Pennsylvania Power & Light Co.

1. PAGE 1 OF 32
2. BCN NO. 21
3. CHANGE PACKAGE NO. _____

BINDER CHANGE NOTICE

Add the analysis, "Environmental Qualification Analysis of 250 VDC Limitorque Motor Operators for Valves Located Outside of Containment of Susquehanna Steam Electric Station," dated October 31, 1990, contained in pages 5 thru 32 of this BCN to provide a basis for the environmental qualification for Limitorque motor operators to be extended to 250 VDC motors and switches used in the operators. The extended qualification is based on testing supplemented by analysis and meets the qualification requirements of 10CFR50.49 and Regulatory Guide 1.89, Revision 1. The analysis concludes that the 250 VDC motor operators are qualified for their outside of containment applications for the full range of dc system voltages included the peak system voltage of 288 VDC.

Figure A.

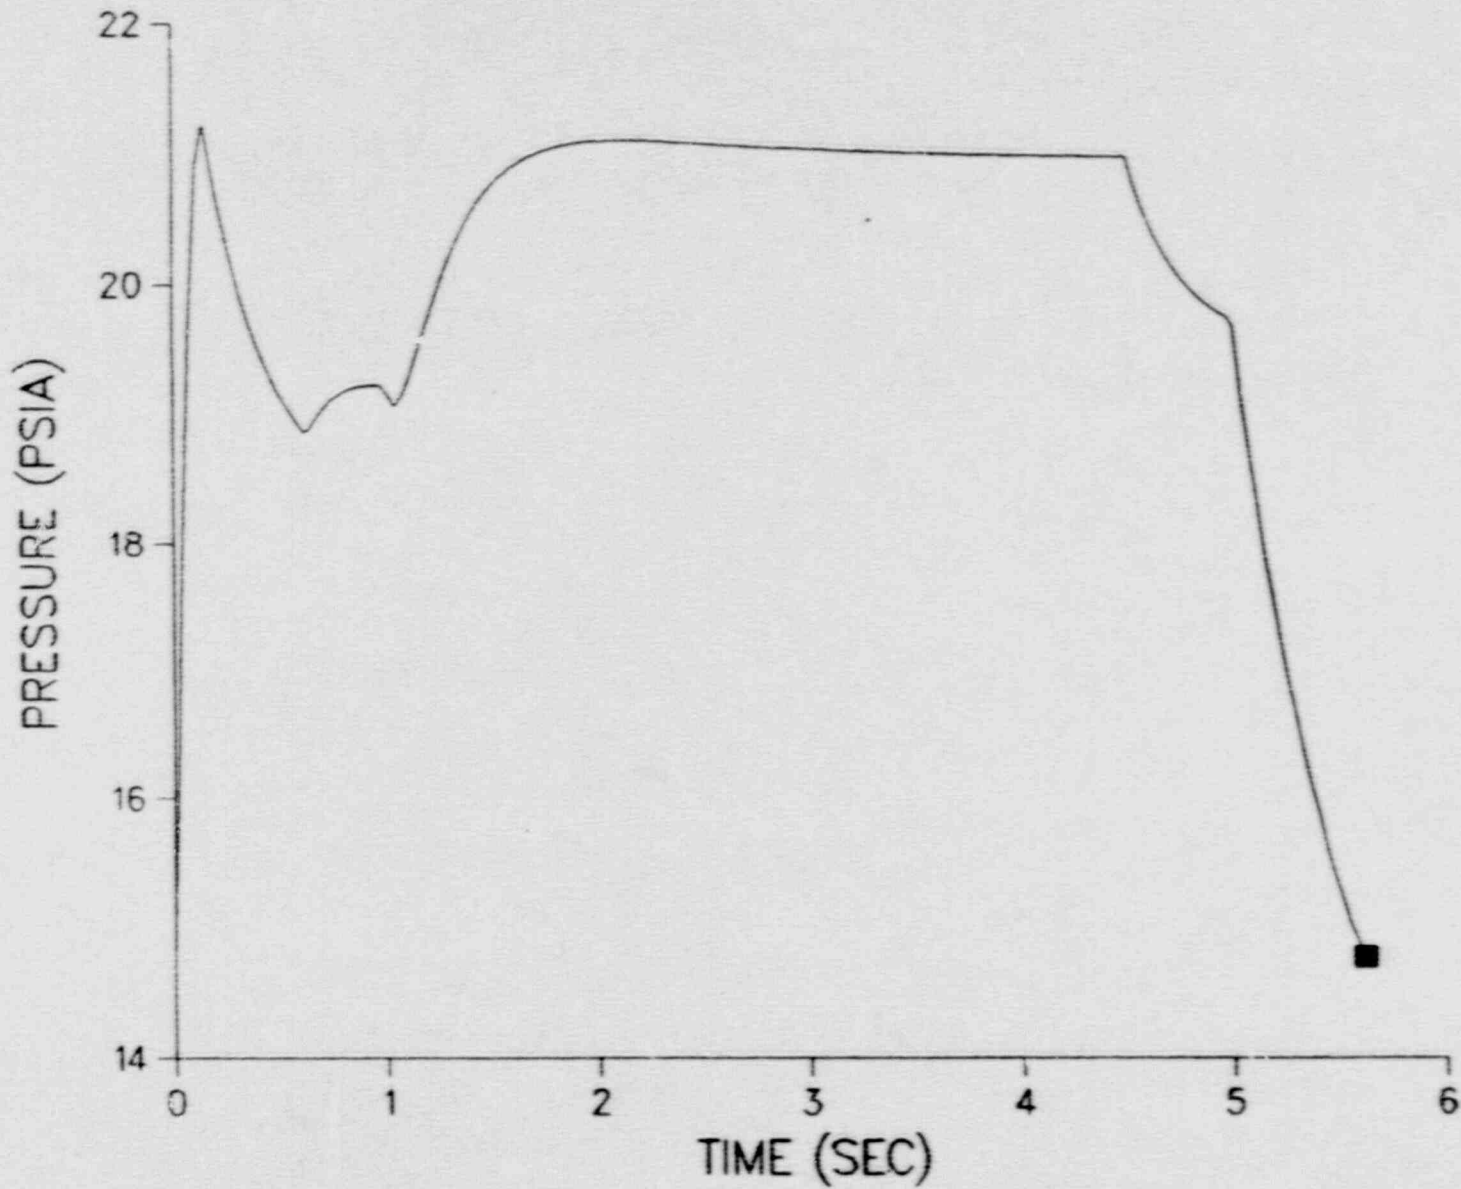
For the HELB in the Main Steam Tunnel (Rooms I-520 and II-520), the new calculation results in a peak pressure of 6.5 psig with a duration of five seconds (See Figure A on page H). This profile is different from that in Figure 1 of the analysis; however, the analysis of the HELB condition contained on page 12 of the analysis envelopes the 6.5 psig, 5 second duration because the analysis is based on the transient associated with a 66 psig saturated steam condition for a five second period, which is much more severe. Therefore, the 250 VDC motor operators are qualified for their Main Steam Tunnel applications.

Figure 1. HELB Profile for Group A Rooms

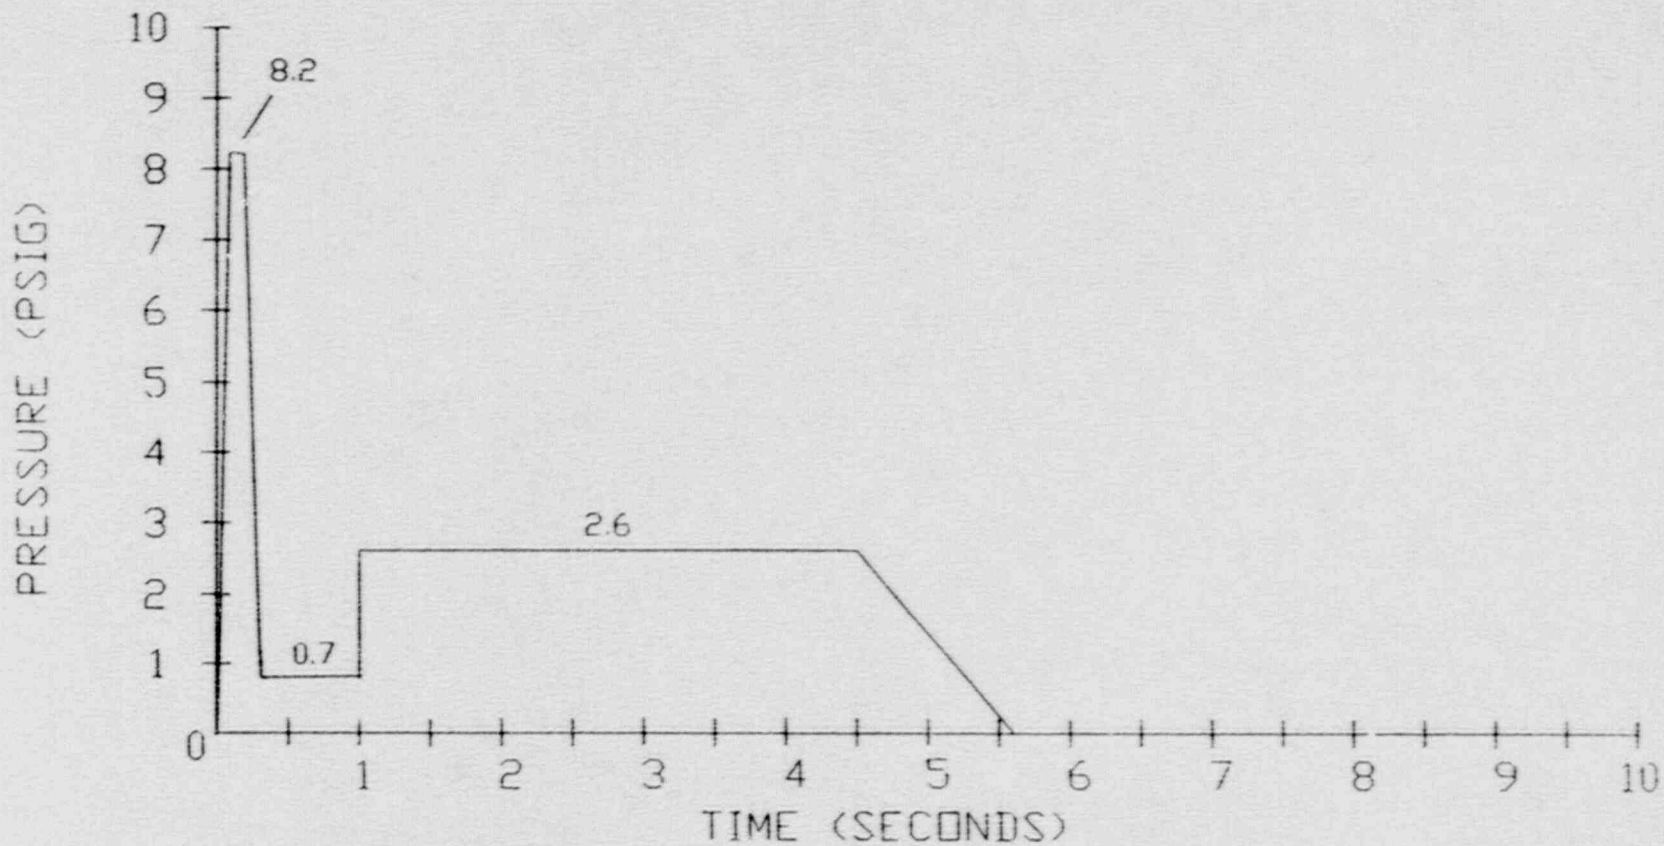
The pressure conditions listed in the Notes to Tables 1 and 2, in Table 3, and in Figures 1 and 2 of the attached analysis must be revised accordingly. The discussion of HELB conditions starting on page 6 of the analysis must be revised as well as the "HELB Humidity and Temperature Analysis", contain on pages 12 through 18, to agree with the new calculation.

When this binder is upgraded, incorporate the analysis on pages 5 thru 32, adjusted for the new HELB conditions from Calculation SE-B-NA-104, Revision 0, into the EQ Assessment Report. Calculation SE-B-NA-104 should be used as a reference in place of the Bechtel calculations listed as references 2 & 3 on page 24 of this BCN.
